Model: FR6		Date: 31-Oct-97	No: 001	1/35
Subject: New Model FR6 Release			Prepared by: K. Misugi	
From: Technical Service Department			Checked by: S. Fujii	
Classification:	<input type="checkbox"/> Troubleshooting	<input type="checkbox"/> Part information	<input type="checkbox"/> Action required	
	<input type="checkbox"/> Mechanical	<input type="checkbox"/> Electrical	<input type="checkbox"/> Service manual revision	
	<input type="checkbox"/> Paper path	<input type="checkbox"/> Transmit/receive	<input type="checkbox"/> Retrofit information	
	<input checked="" type="checkbox"/> Other ( )

The new model FR6 (FAX3800L) has been released as a successor model to the FX6 (FAX2700L).

This technical bulletin contains information on differences between the FR6 and the FX6. They are listed in order of sections that appear in the service manual.

**Fig.1**

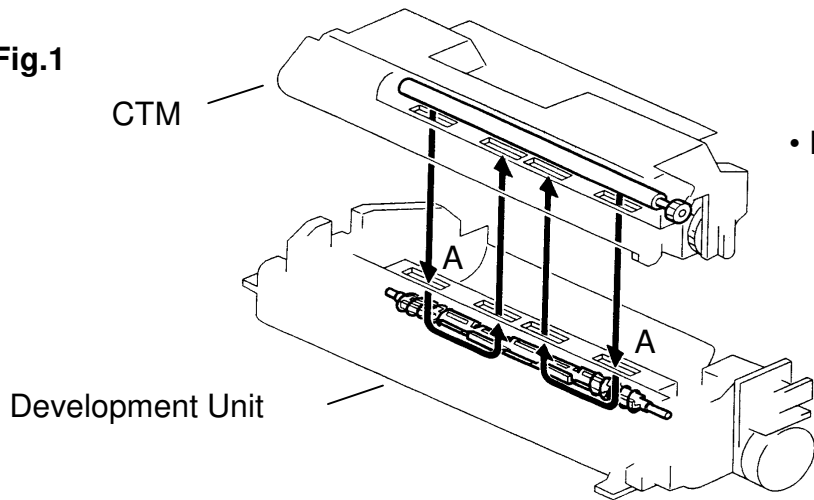
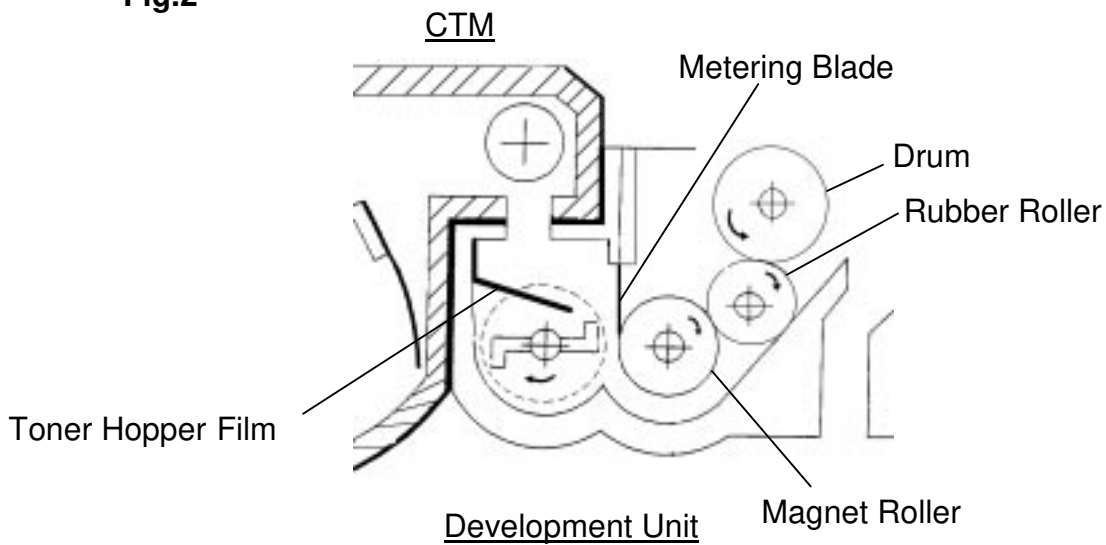
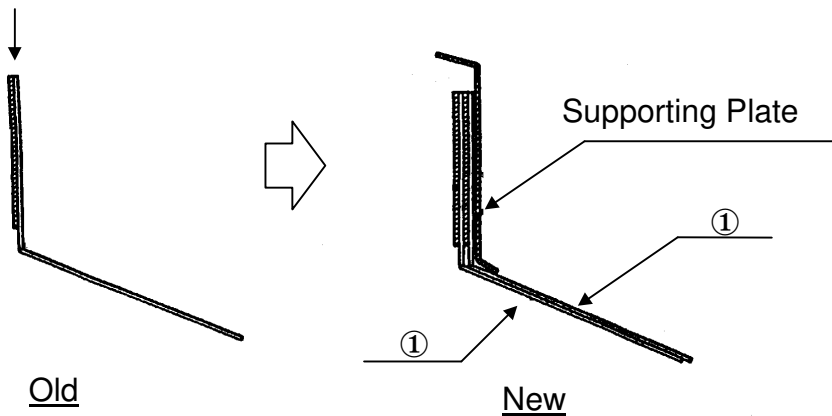
The A4 development unit was modified to improve the flow of the toner in the development unit. See page 2.

\*This modification prevents the Kattsumari problem (vertical gray bands on print outs) caused by blocked toner in the middle of the development unit. The blocked toner bends the toner metering blade. The toner enters the drum area through the gap made by the bent blade. Once in the drum area, the toner collects on the drum and causes the gray bands on the print out.

- Length of the toner entrance (A) becomes smaller. (30mm → 18mm)

① Toner Hopper Film

- Two toner hopper films are stuck together.
- A supporting plate is attached to the toner hopper film.

**Modified parts:** (H515 9570 → H515 9571) Development unit

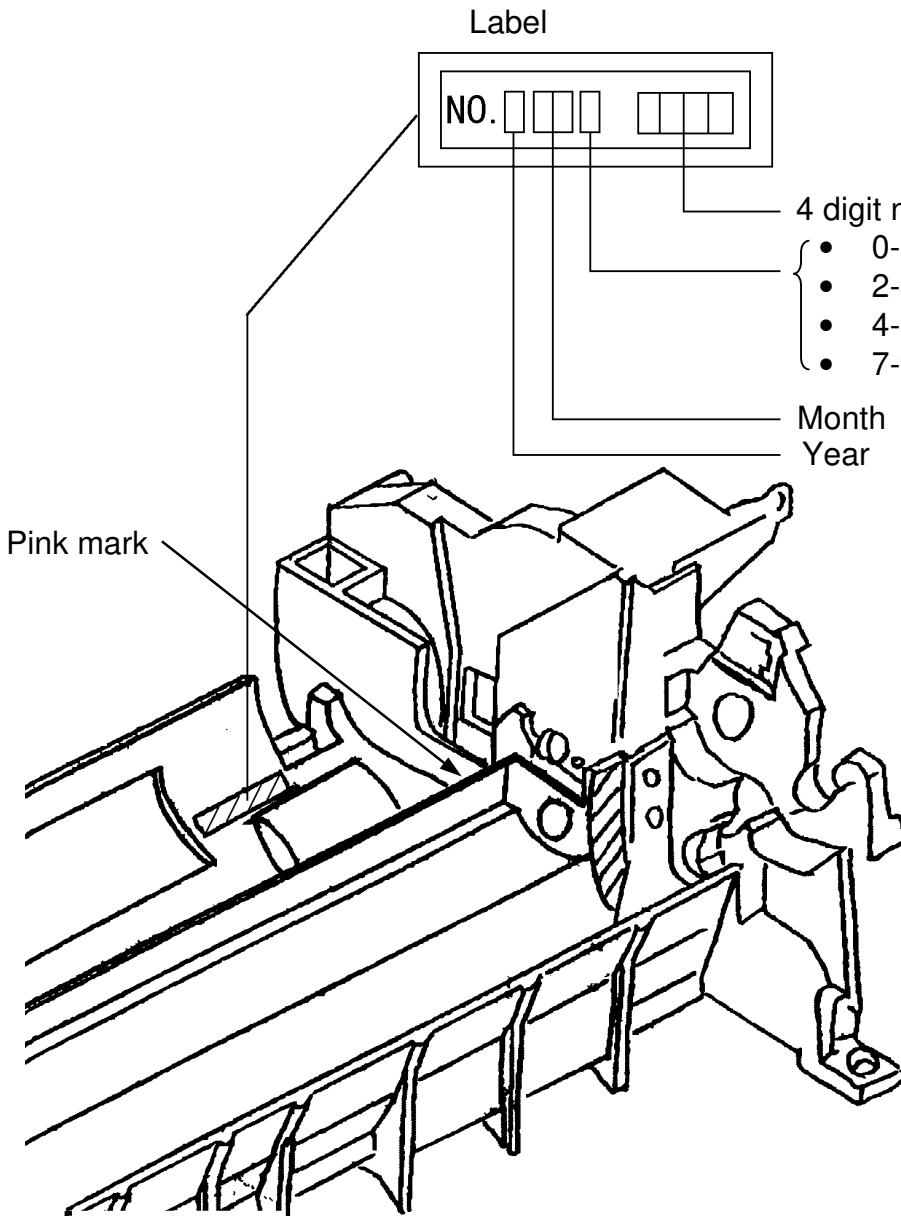
You can distinguish the modified development unit by the lot no. printed on the label. See page 3.

Ex.70810012  
 =12th Dev. Unit for LS0 Series  
 made in August, 1997

No. for the new units  
 (FX4, FX6 Series – A4)

- H551 series

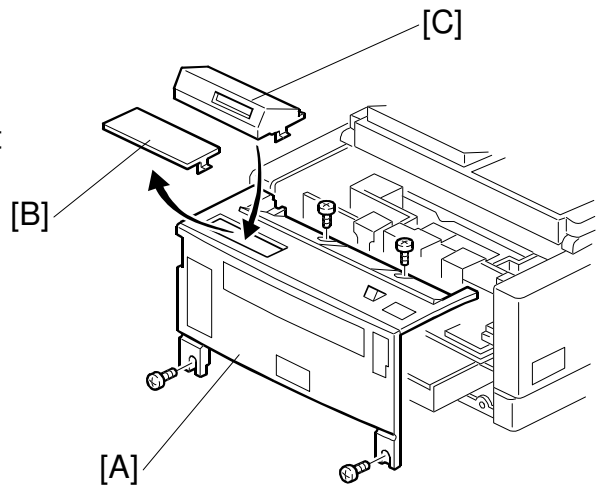
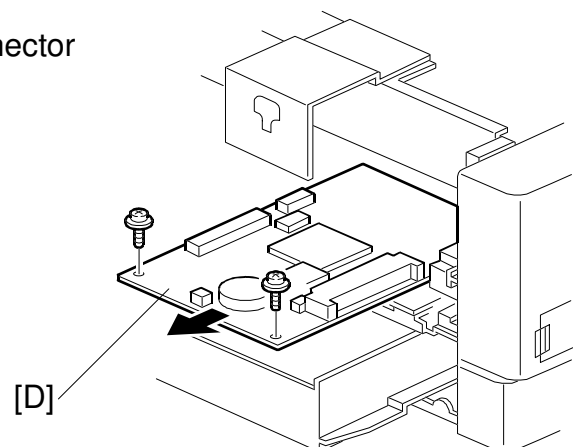
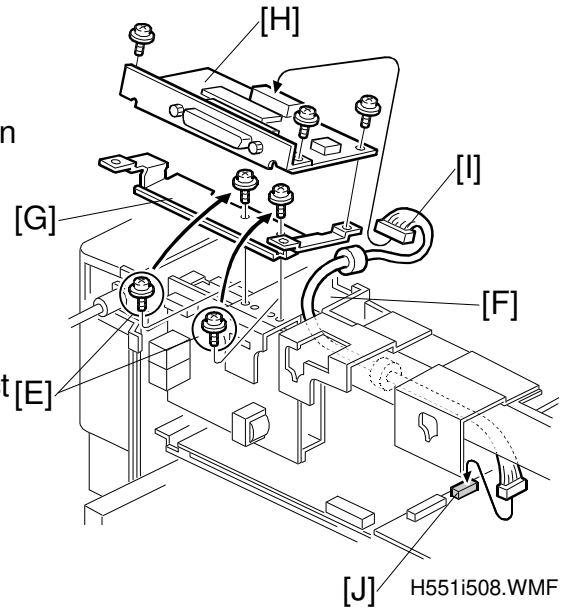
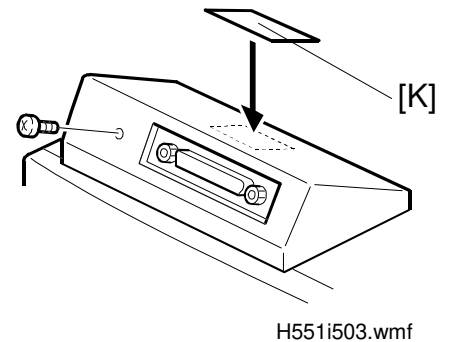
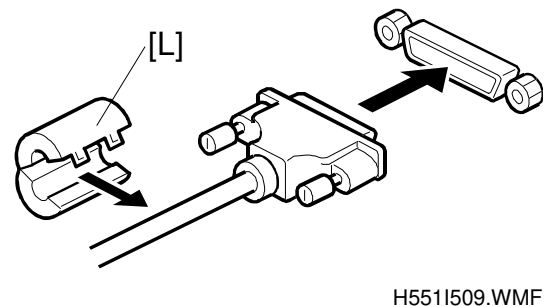
This RTB is to correct information in the installation procedure of the PC-Fax Expander Type 141 and Type 110.

1. Remove the rear cover [A] (4 screws).  
Remove the RS232C cover [B] and replace it with the PCFE cover [C].

2. Remove two screws, disconnect the FDU connector and pull out the FCE [D] as shown.

- Remove two screws [E] on the grounding plate [F], then attach the bracket [G] to the machine.  
**NOTE:** The grounding plate [F] is not installed in the USA models.

- Secure the PCFE board [H] (3 screws). Connect the harness [I] to the PCFE board and the FCE (CN5) [J].

- Replace the FCE, rear cover, and secure the PCFE cover (1 screw). Attach the "PCFE Port" decal [K] on the PCFE cover.

- Attach the core [L] to the RS232C cable. Then, connect the PC-Fax Expander port to the PC port using the RS232C cable. Plug in the machine and turn on the main switch. Set System bit switch 06 bit 5 to "1." **Then turn the main switch off and on to enable the PC-Fax Expander.**
